# **FINAL DRAINAGE REPORT FOR STERLING RANCH FILING NO. 2**

## **EL PASO COUNTY, COLORADO**

MARCH 2018

**SF-1820**

Project: **STERLING RANCH FILING NO. 2**  
Basin ID: **POND W-5**

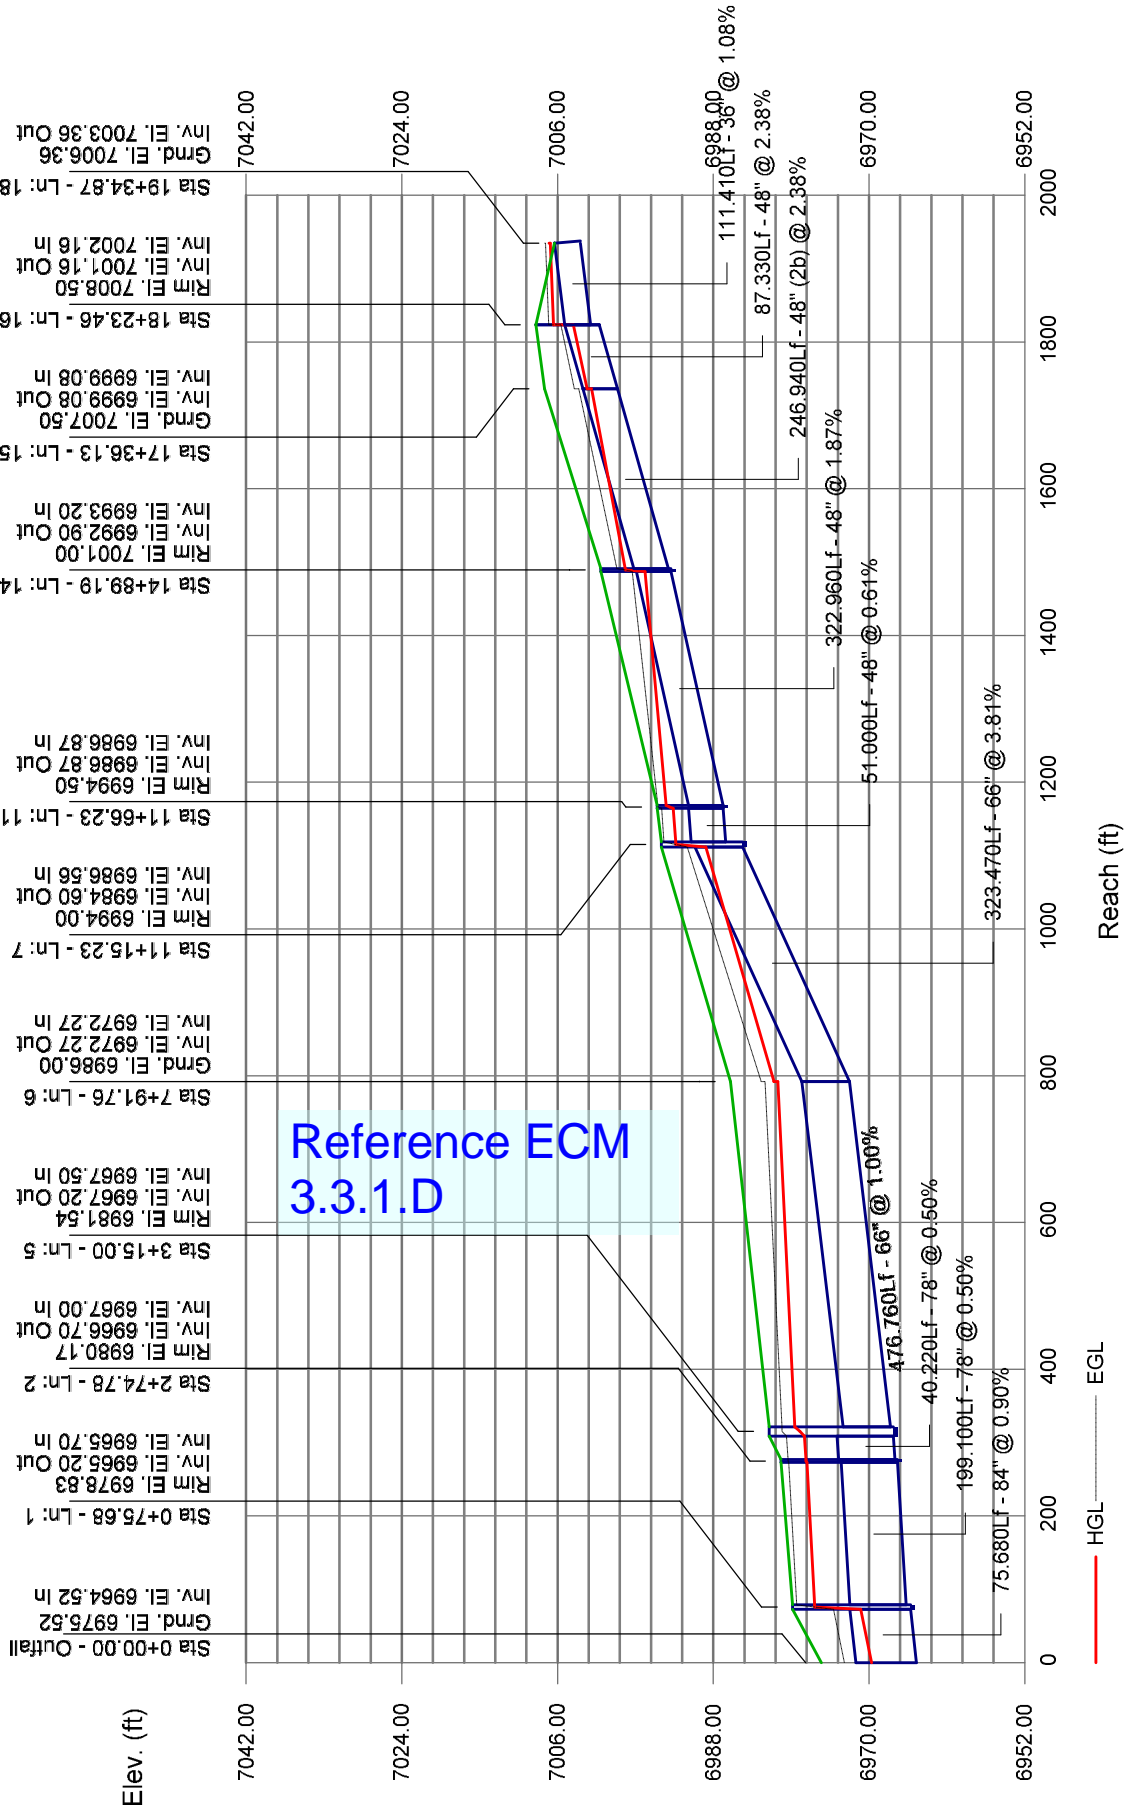
Adjust to be <1; provide comparison to historic drainage area allowable flows for all return periods.

Project: **STERLING RANCH FILING NO. 2**  
 Basin ID: **POND W-4 INTERIM**

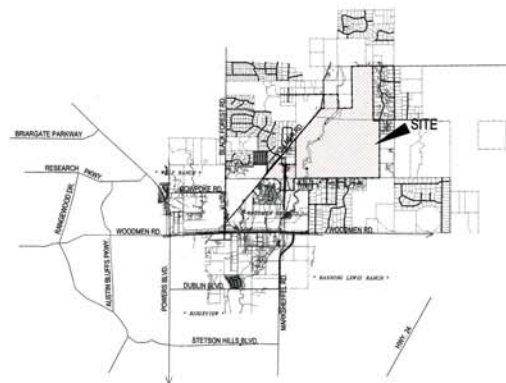
This presents a safety issue

Provide the SDI worksheets that demonstrate the detention ponds comply with Colorado Revised Statute 37-92-602(8). Provide this as a separate document.

**STERLING RANCH MDDP**  
**HISTORIC - DRAINAGE MAP**

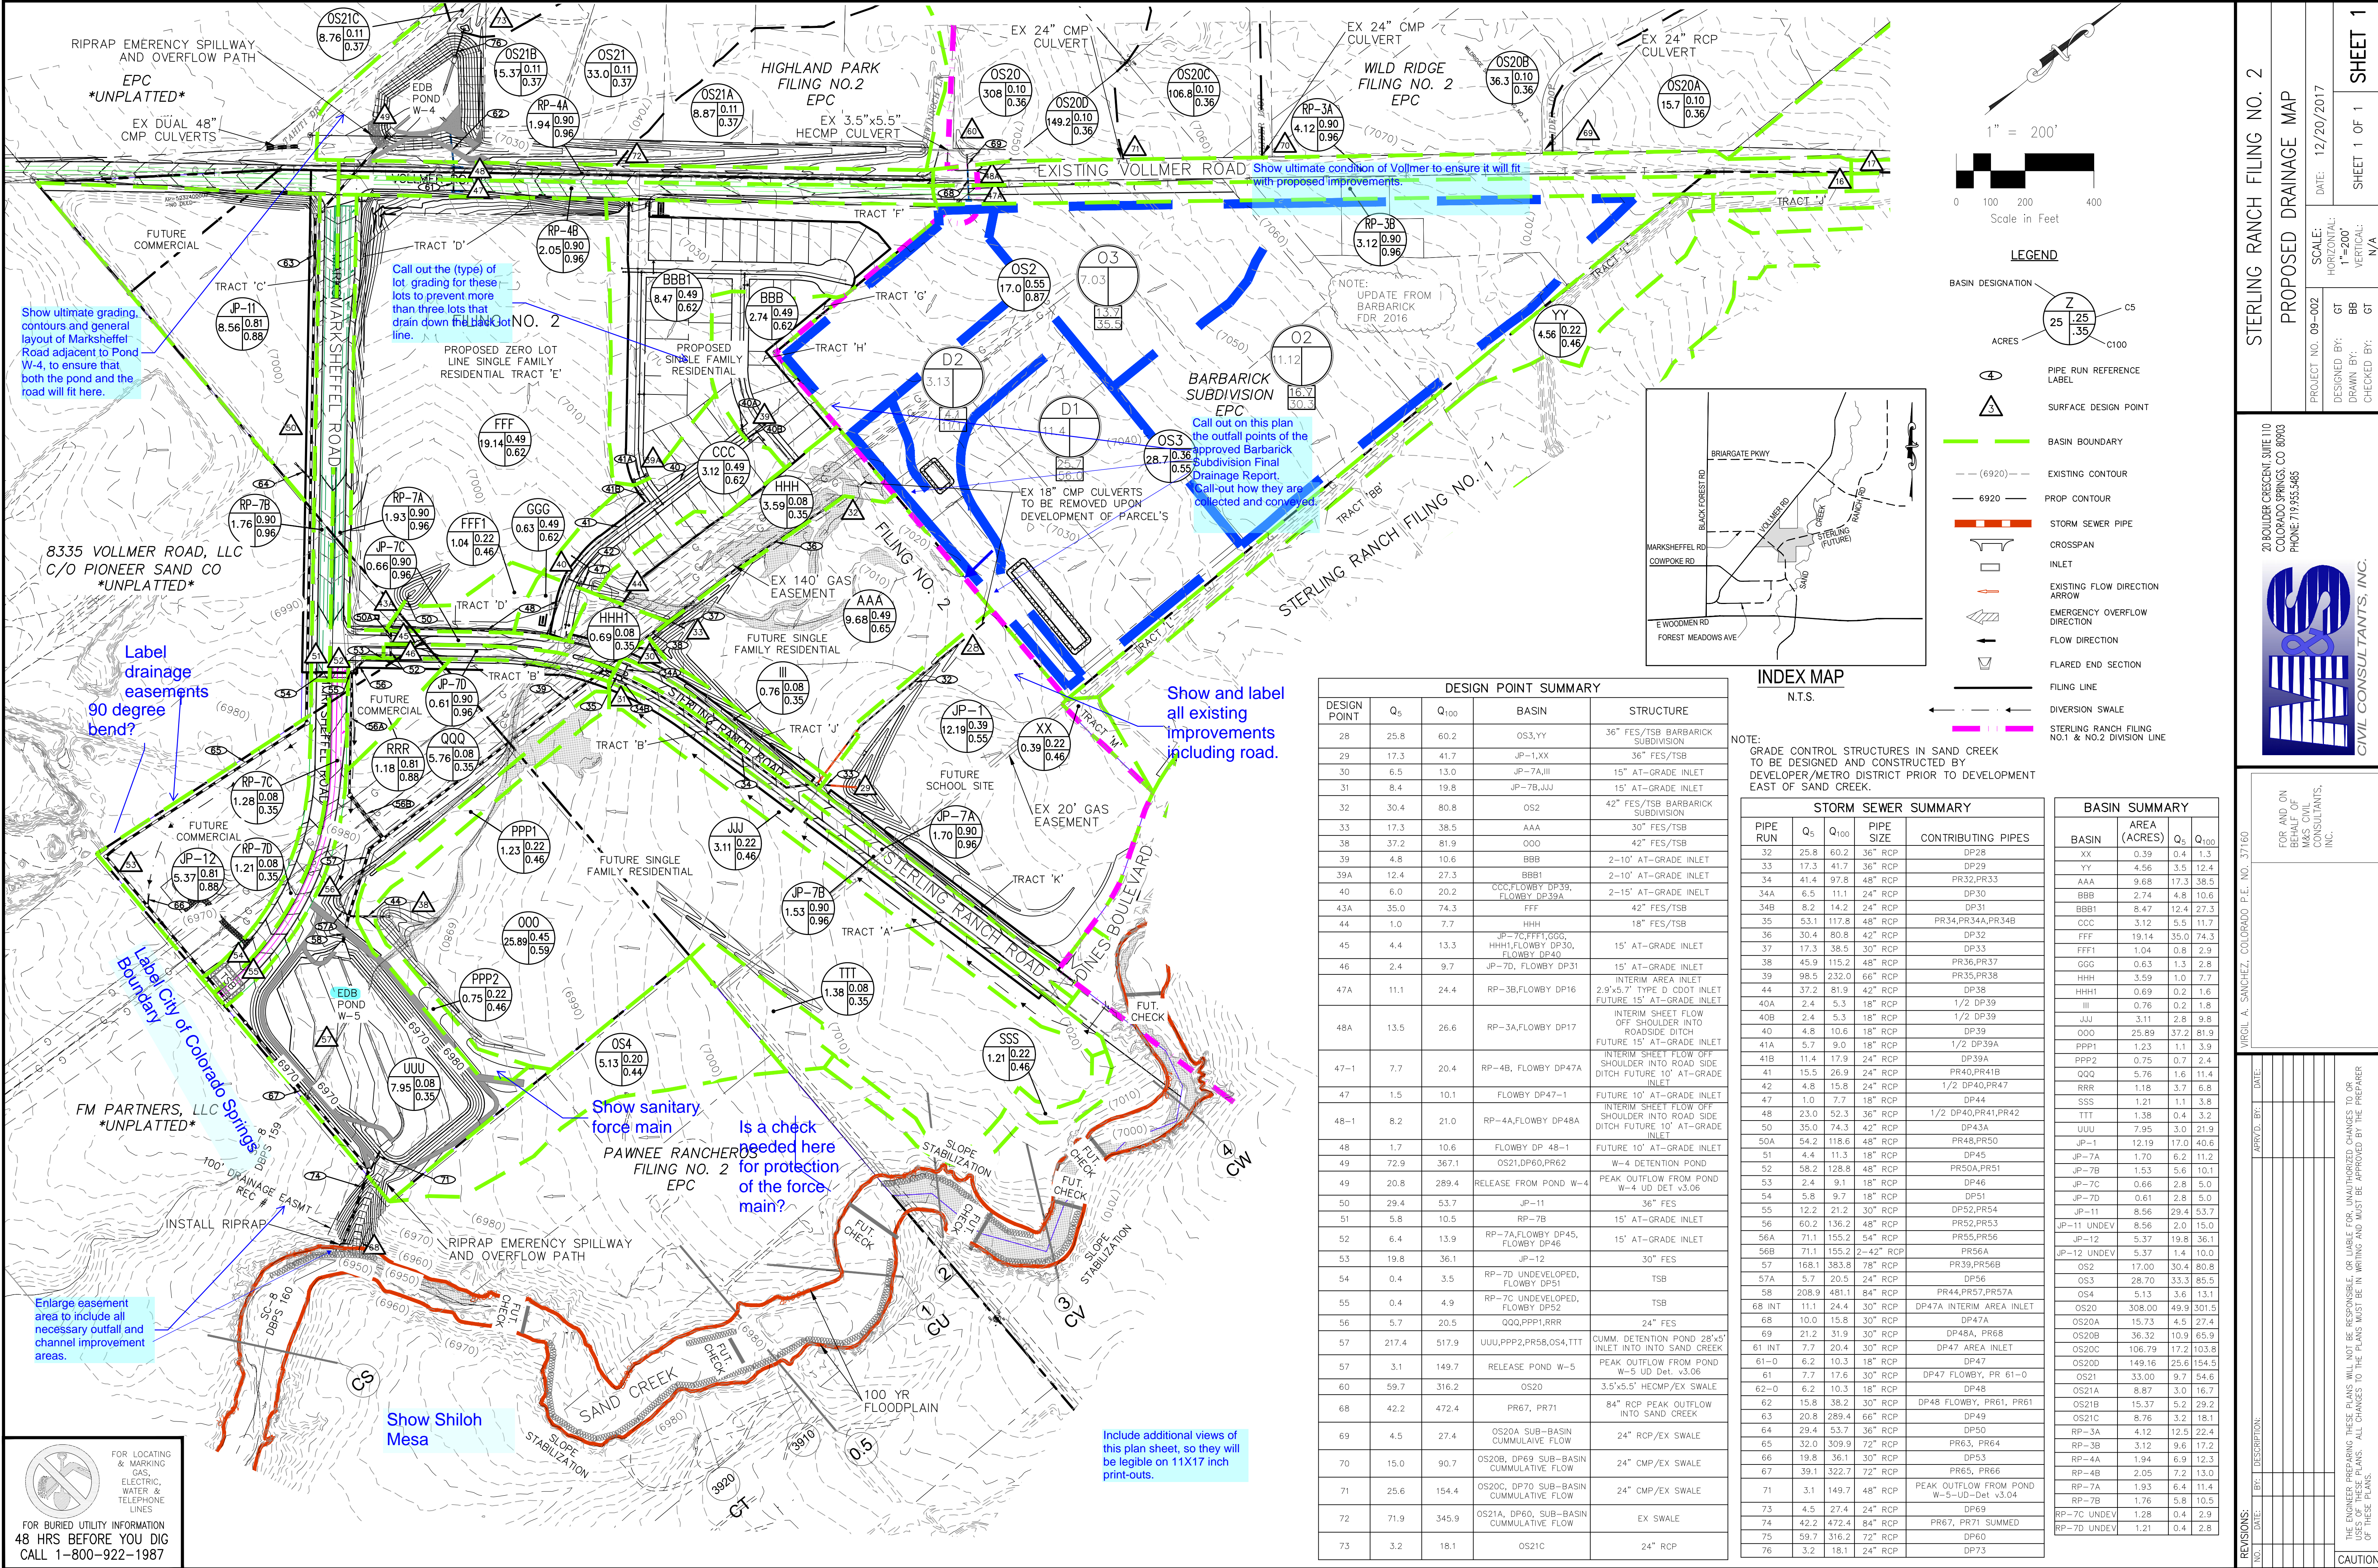
Please provide an additional existing condition drainage map at the same scale as the proposed condition map. This exhibit should show the show the boundary for this site.
